# Drive-Thru Kiosk & Carwash Land Use Applications

**Coffee Kiosk: PC 20 13 DR 01**

**Car Wash: PC 20 14 DR 02**

# Staff Recommendation

# Photometric Plan-Kiosk

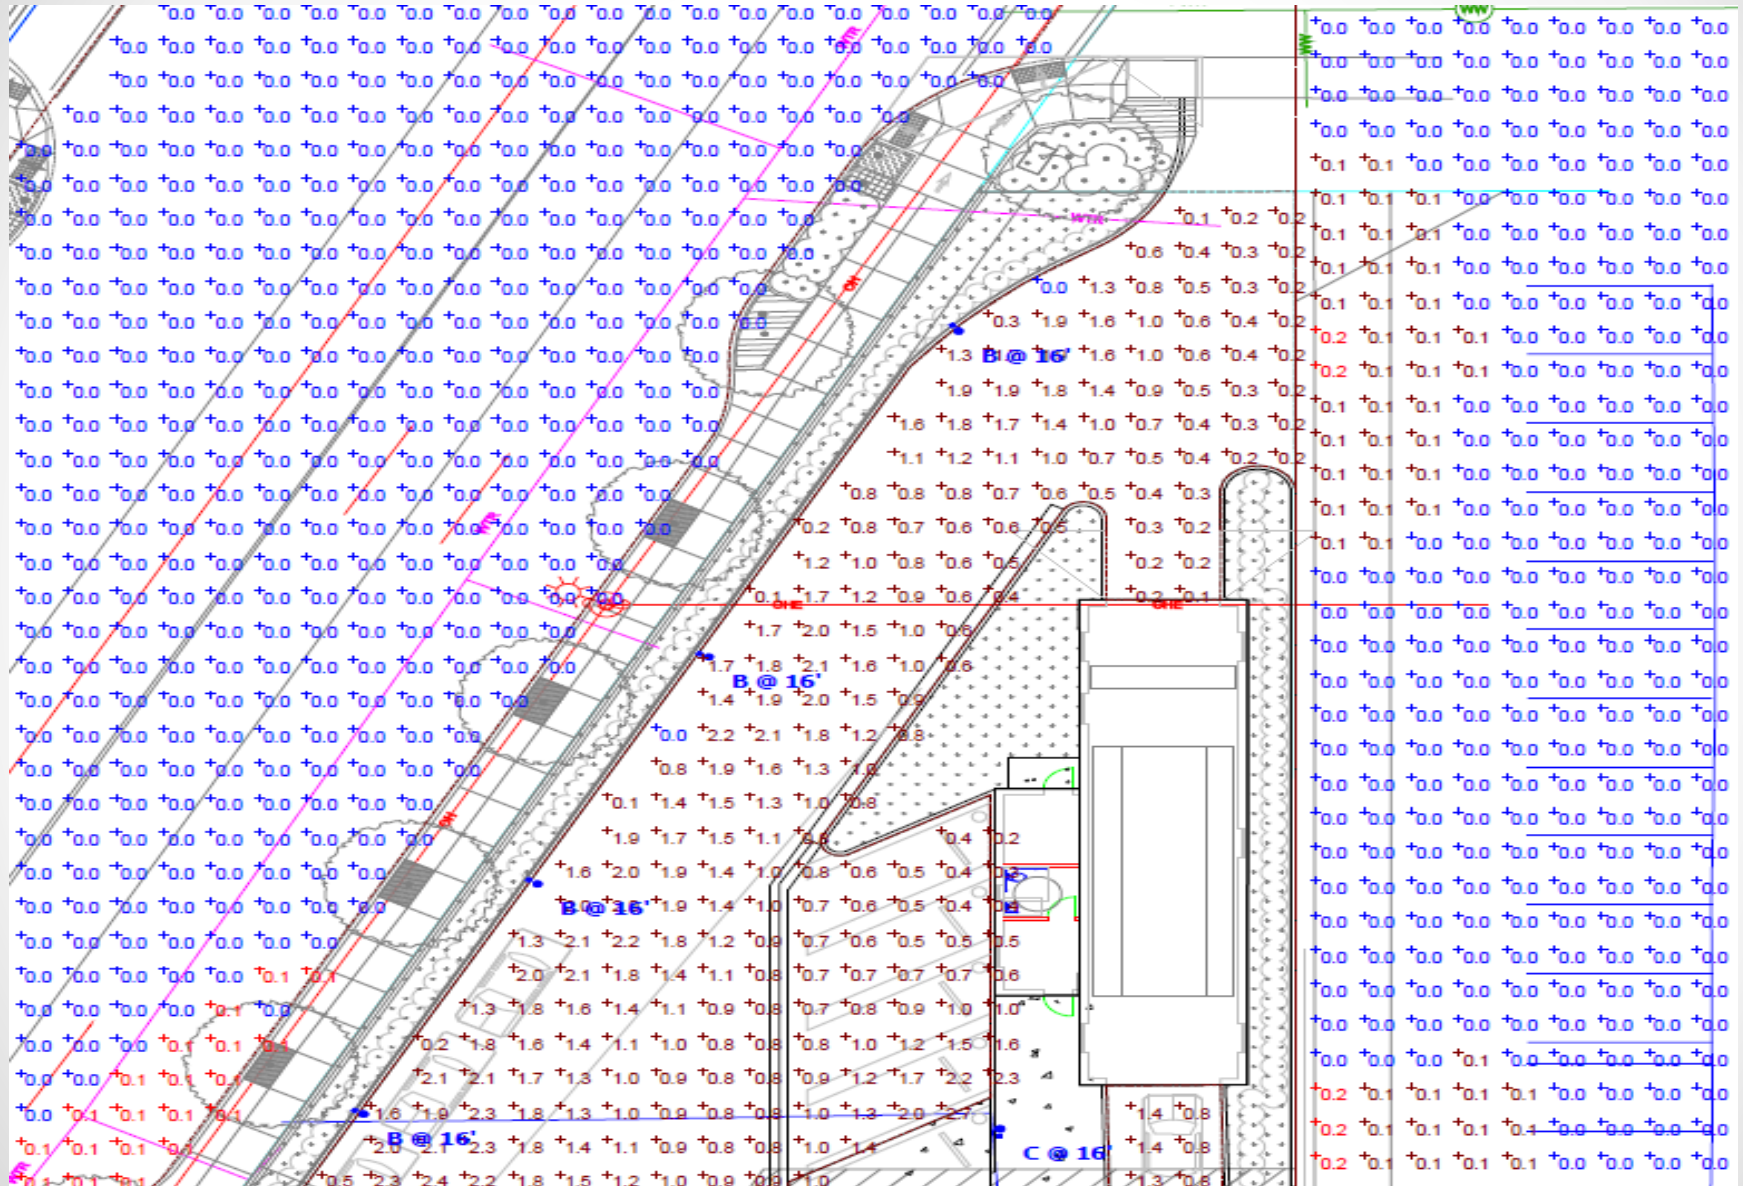
Only 8 “B”s & 3 “C”s are indicated on Plan

22 & 23. Lighting Plan to be revisited
